Re: Florida Power & Light Company
Proposed Turkey Point Units 6 and 7
Docket Nos. 52-040 and 52-041
Voluntary Submittal of Exemption Request and Design Change
Description for Departure from AP1000 DCD Revision 19 to Address
Compliance With IEEE 603-1991

Subject: [External_Sender] L-2016-083-Voluntary Submittal of Exemption Request and Design Change Description for Departure from AP1000 DCD Revision 19 to Address Compliance With IEEE 603-1991

DCD Tier 2 Change

Figure 7.2-1 (Sheet 3 of 21)

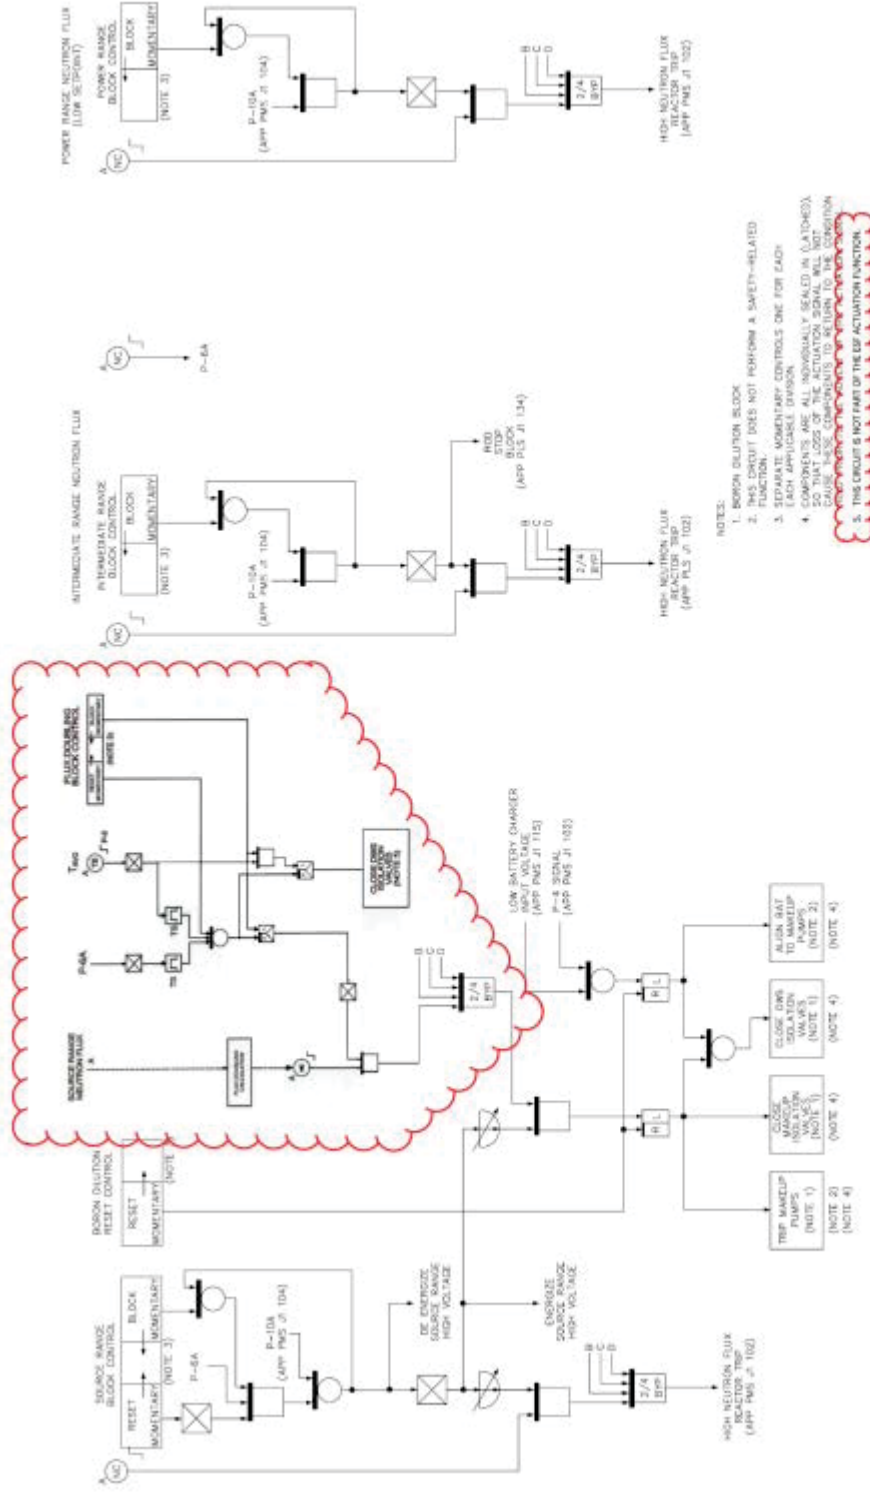
- Figure 7.2-1 (Sheet 3 of 21); Add logic for condition when source range flux doubling signal may be manually blocked and automatically reset.
- Section 7.3.1.2.14, Boron Dilution Block; Revise discussion of conditions when the source range flux doubling signal may be manually blocked and when it is reinstated.

- 1) Add a new permissive, P-8, to permit blocking the flux doubling logic during reactor startup. (P-8 provides the logical permissive input to the PMS. P-8 is set to 551°F Reactor Coolant System (RCS) temperature, the minimum temperature for criticality.)

- 2) Add logic that will cause the PMS to force CVS valves 136A and 136B closed if the flux doubling logic is blocked when reactor temperature is less than P-8. (This ensures a permissible condition exists before flux doubling is bypassed below P-8, which is one option from IEEE 603-991, the other being to perform the appropriate safety functions.)

- 3) When RCS temperature is below P-8, reset the flux doubling logic if CVS valves 136A and 136B are opened.
- 4) Add an additional reset of source range flux doubling logic when RCS temperature falls below P-8. Existing PMS design resets flux doubling logic when neutron flux decreases below P-6.
